**PETITION 2015-04 (AZ)(PD) 511 MAITLAND BOULEVARD
PLANNED DEVELOPMENT – OPTION 1
DEVELOPMENT REVIEW COMMITTEE RECOMMENDATION
OCTOBER 1, 2015**

P&Z Direction
 Petition No 2014-04 (AZ)(PD) Option 1
 511 West Maitland Boulevard (aka Maitland Concourse North)

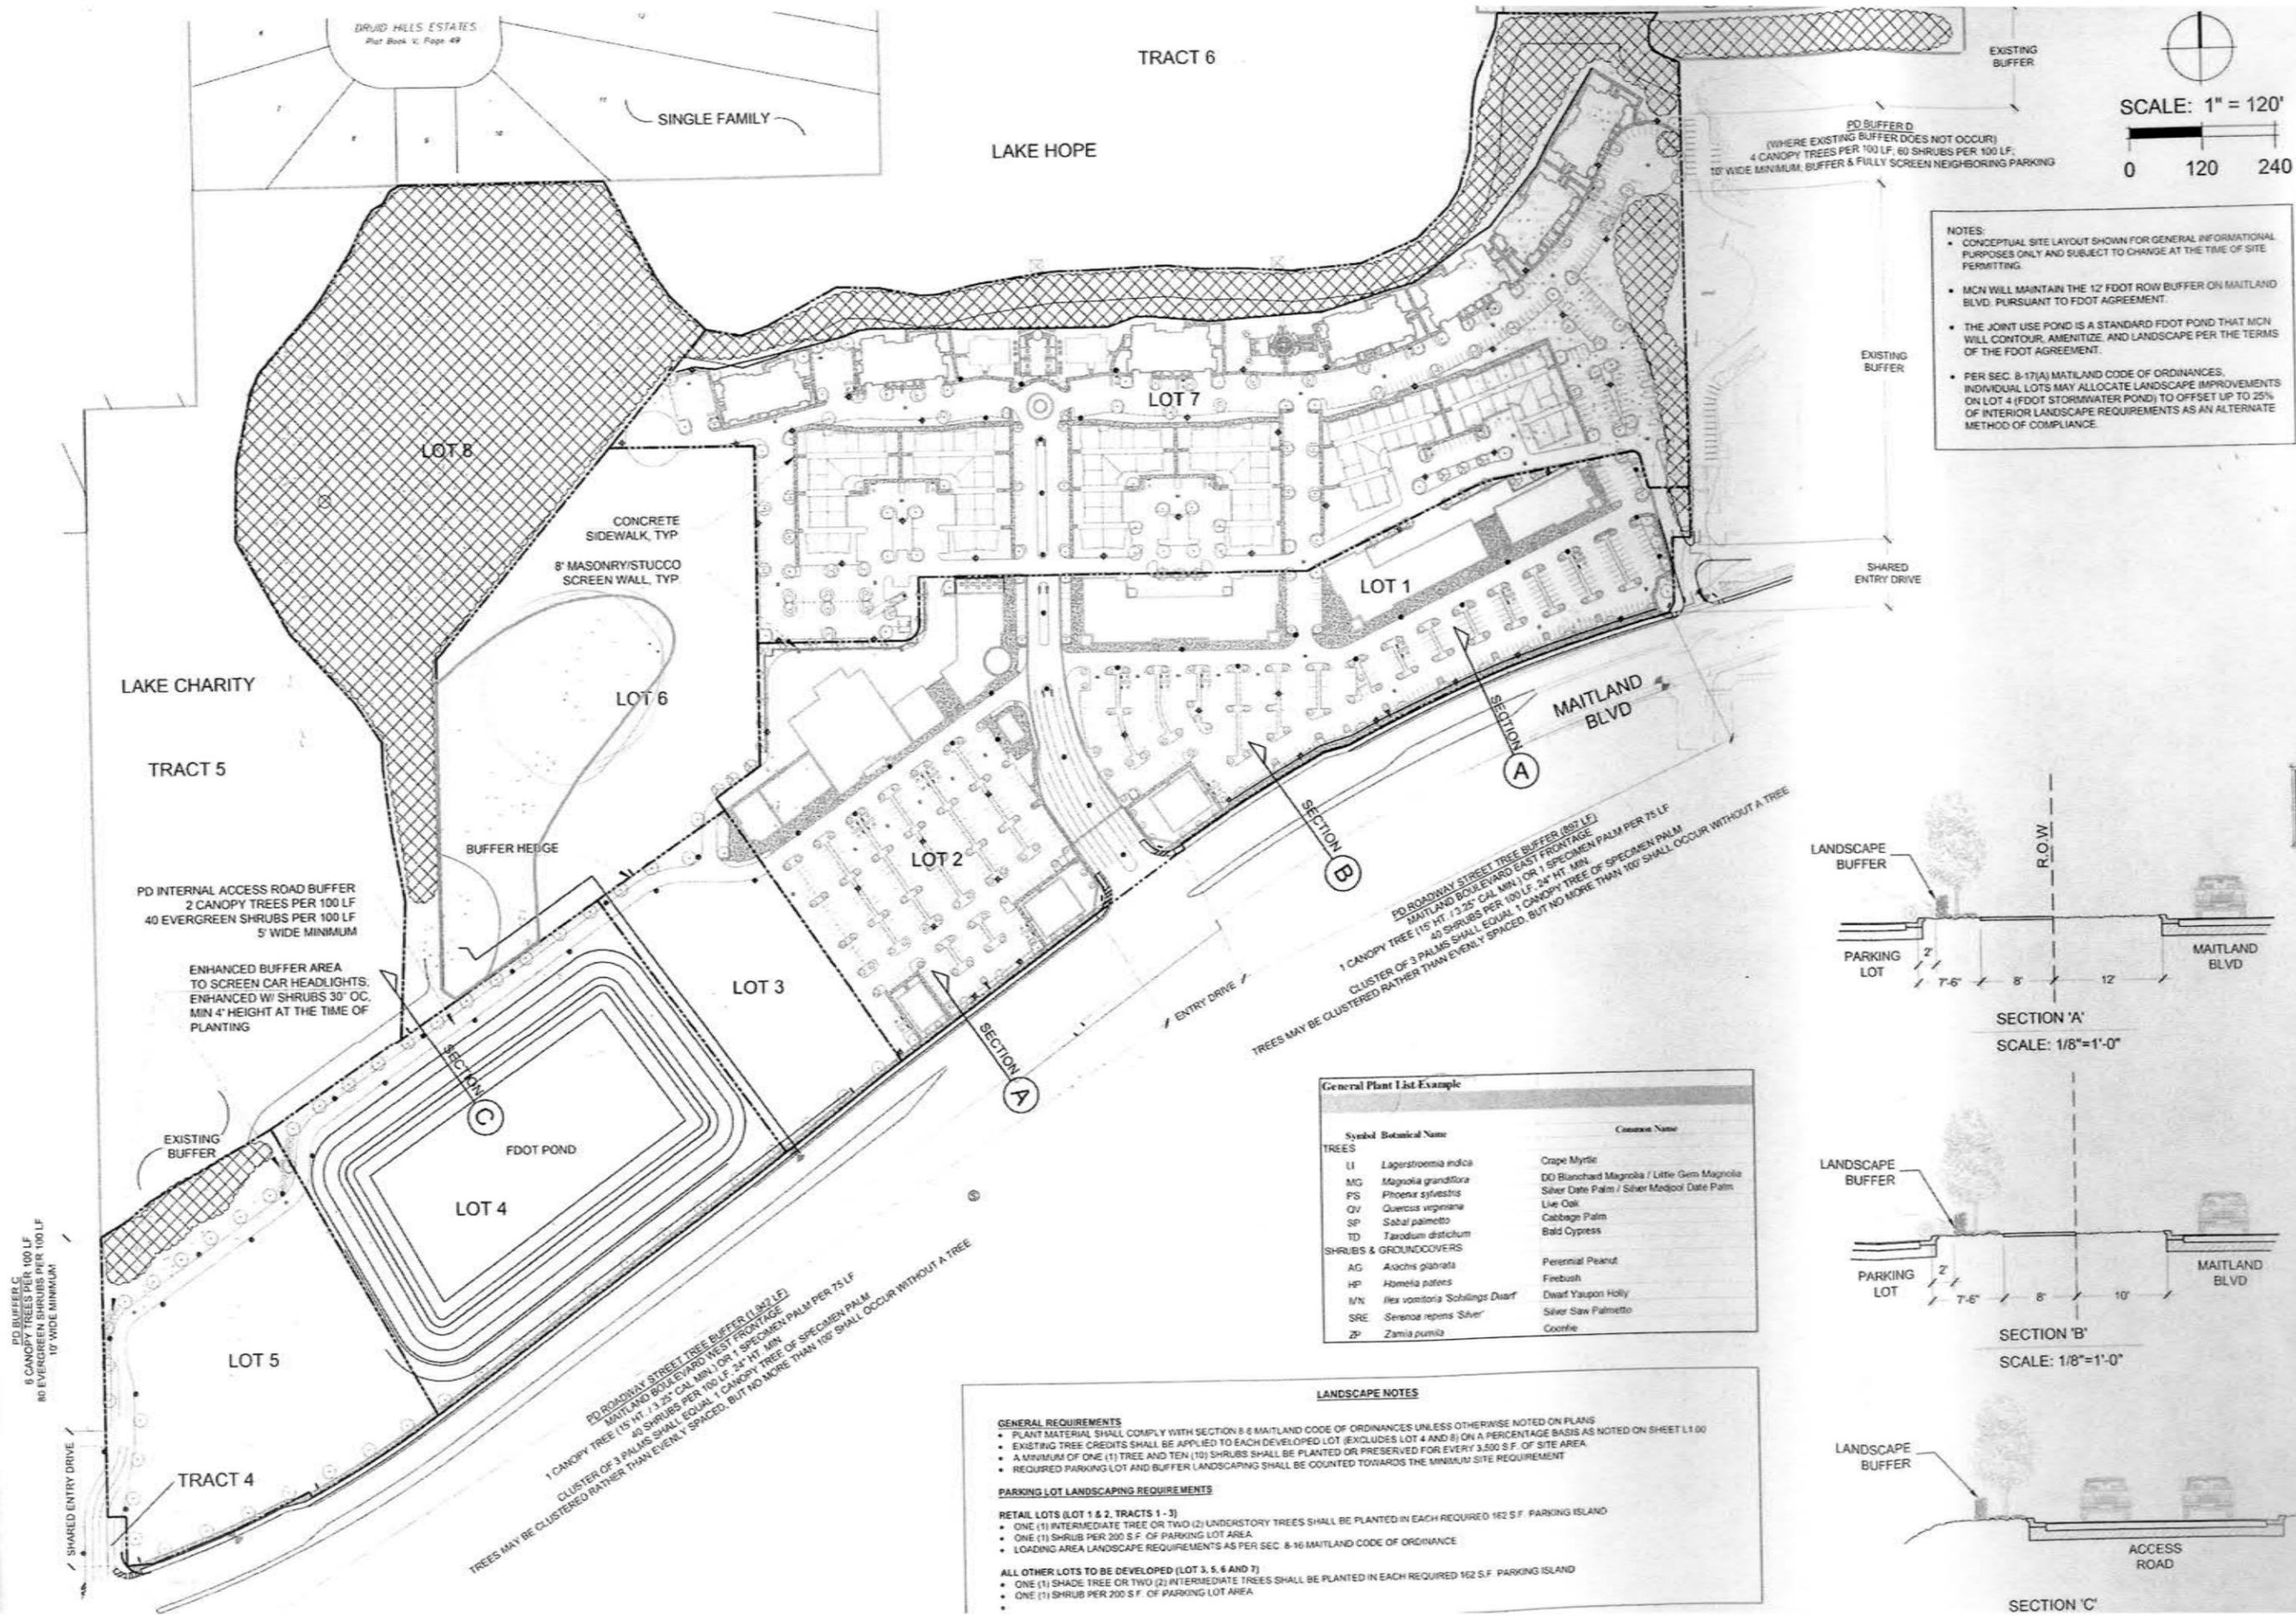
16.	There is a well at the end of Lake Charity that has not been functioning adequately.

Please address this item.	
17.	There is a 60 foot easement on or adjacent to property owned by Bill Ellis at 9031 Lake Hope Drive. Discern who maintains the easement.	30' canal easement exists on private property.

18.	Park was to be dedicated to (receive title to) the City of Maitland.	Item E/ pg. 4/ Lot 8, Item J/pg. 13/14
19.	<p><u>Letter from Kimley Horn - PD Application Option 1 – Maitland Concourse North Requested Code Flexibility due to Unique Characteristics and Design Enhancements to Benefit the City</u> - review this sheet in its entirety and address. Some specific items noted are as follows:</p> <ul style="list-style-type: none"> ➤ Examine buffers and landscape code deviations requested by application. Validate these items. [Item E, pgs. 3/4 , item F pg. 5] ➤ Applicant proposes use of palms in lieu of canopy trees for street trees and at a distance of 1 per 75 feet in lieu of every 50 feet. This is proposed for visibility of retail. Please address this item. (Incorporate canopy trees along Maitland Boulevard to provide shade for pedestrians.) [pg. 8 Roadway Trees] ➤ Review building setbacks. [Pg. 5/6] ➤ Review proposed signage in conjunction with sign code regulations. [pg. 10/11] ➤ Review landscape buffers. [pg. 8] ➤ Review open space and permeable surface. [item F, pgs. 7/8] ➤ Review the parking study and adequacy of parking. [pg. 27, Transportation.] ➤ Provide additional detailed information regarding the fees and credits requested. Impact fees and fee credits requested must be thoroughly reviewed by DRC and evaluated if any credits can or should be granted.[Pgs. 37-41] 	Refer to notes in column to the left.
